Form 3160-5
(June 2019)UNITED STATES
DEPARTMENT OF THE INTERIOR
BUREAU OF LAND MANAGEMENTFORM APPROVED
OMB No. 1004-0137
Expires: October 31, 2021**SUNDRY NOTICES AND REPORTS ON WELLS**
Do not use this form for proposals to drill or to re-enter an abandoned well. Use Form 3160-3 (APD) for such proposals.

8. Well Name and No.
MIDNIGHT HOUR 11 FED COM/725H

EOG respectfully requests an amendment to our approved APD for this well to reflect the following changes:

Revised Wellbore

Figure 1: Cameron TA Plug and Offline Adapter Schematic

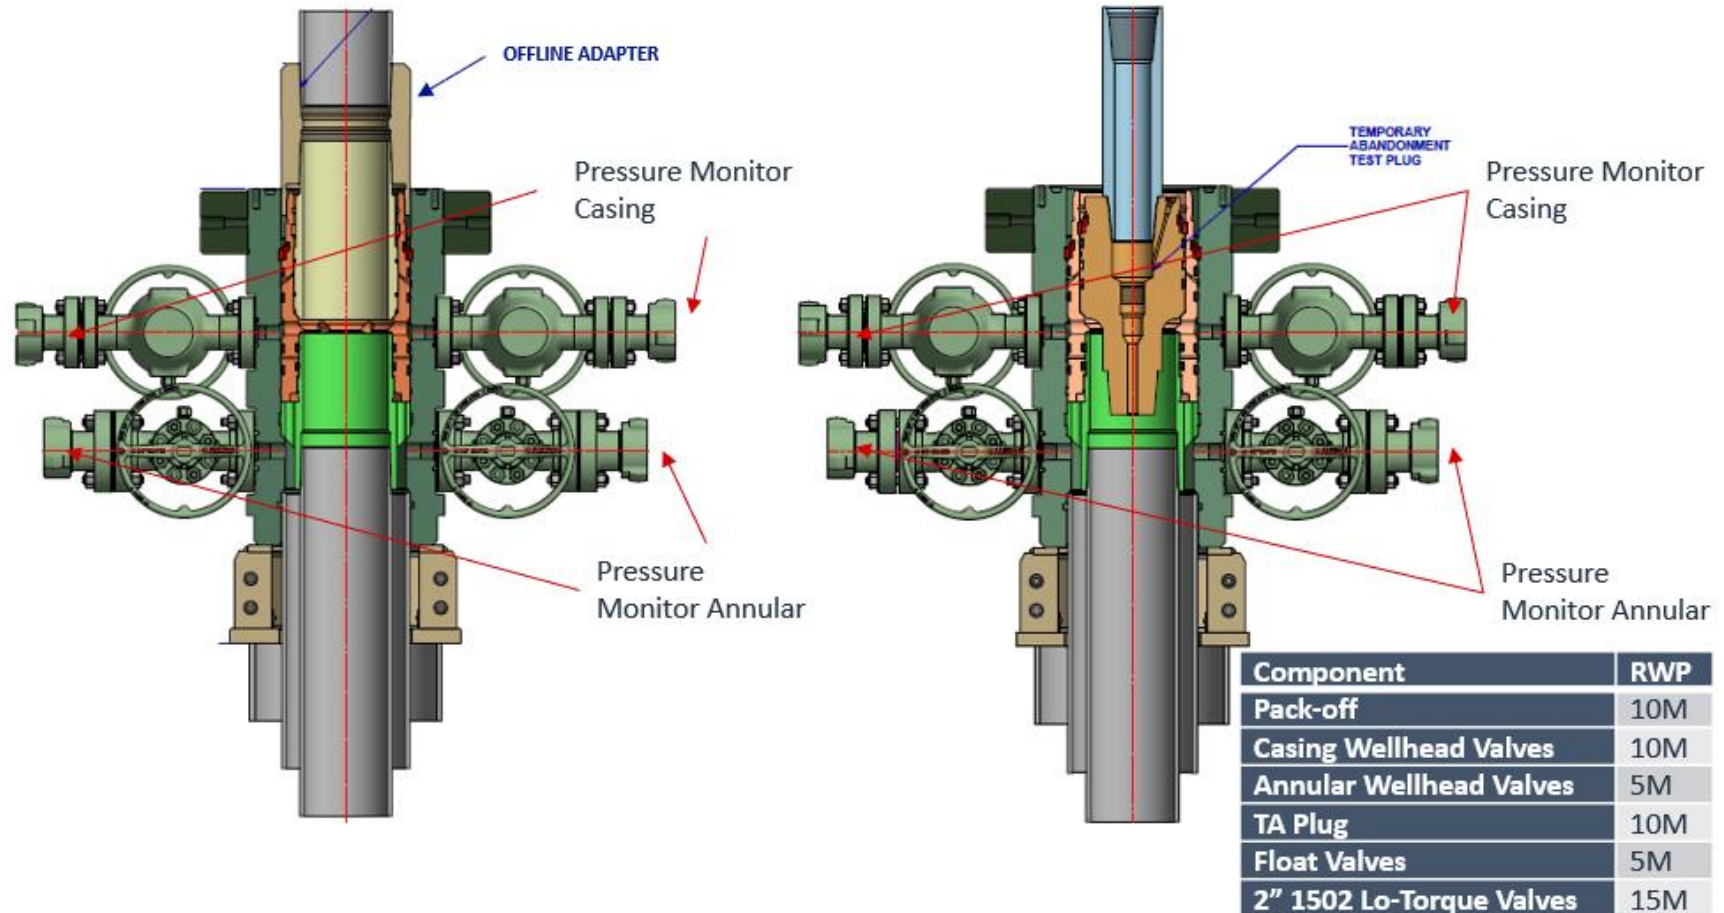
- c. Return line schematics can be seen in Figure 3.
10. Remove TA Plug from the casing.
11. Install offline cement tool.
 - a. Current offline cement tool schematics can be seen in Figure 1 (Cameron) and Figure 2 (Cactus).

Figure 4: Rig Placement Diagram

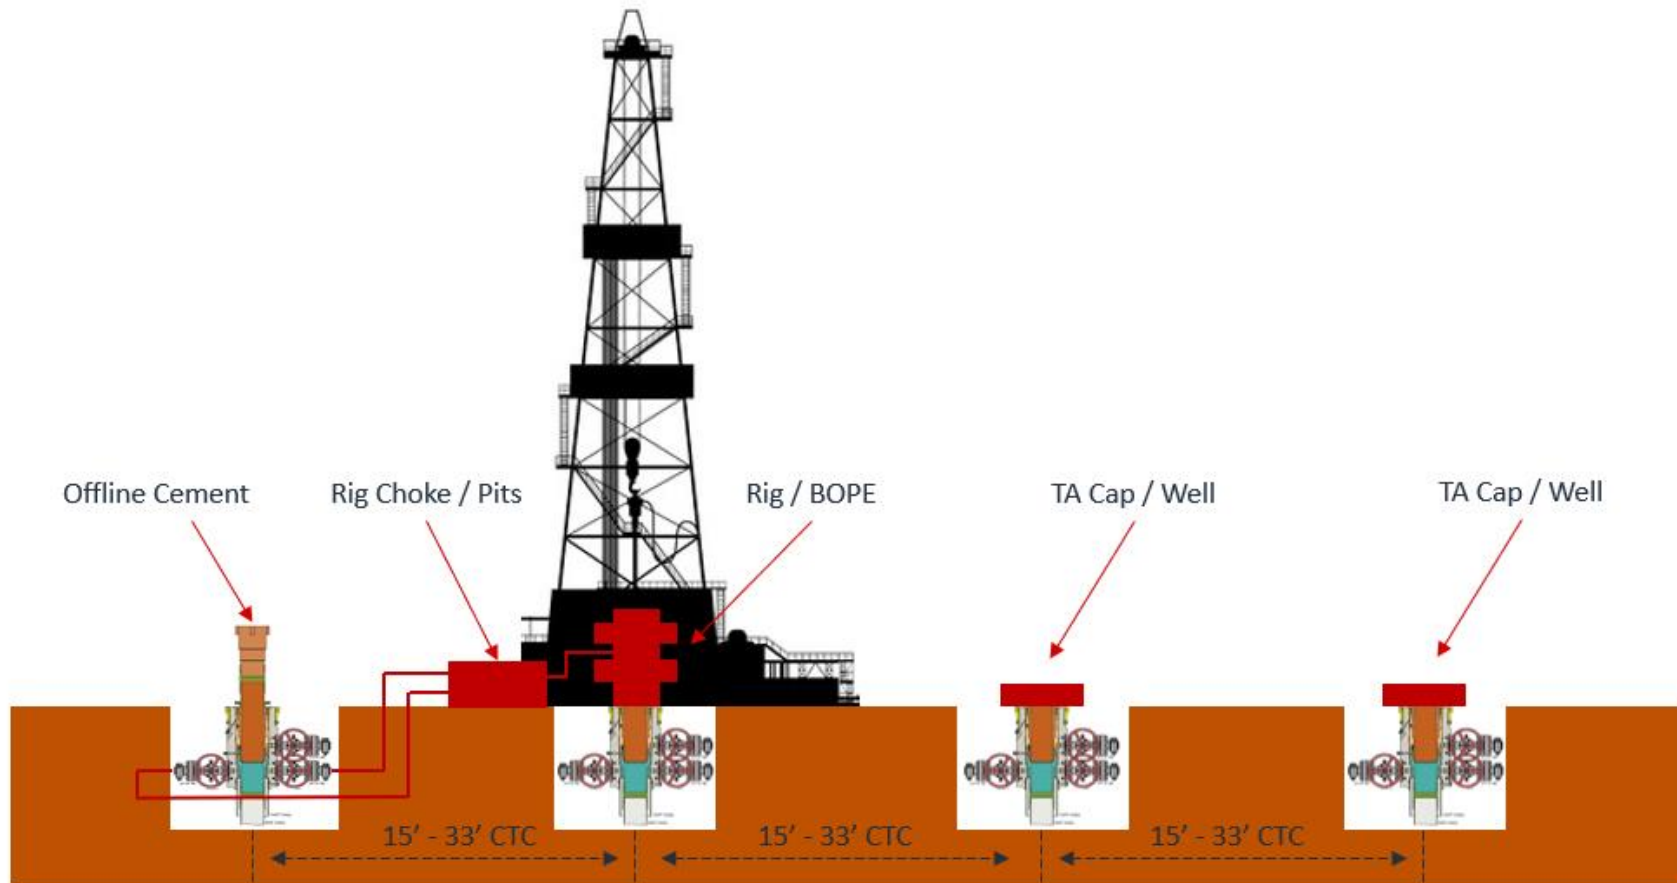
- e. Diagram for rig positioning relative to offline cementing can be seen in Figure 4.
9. Rig up return lines to take returns from wellhead to pits and rig choke.
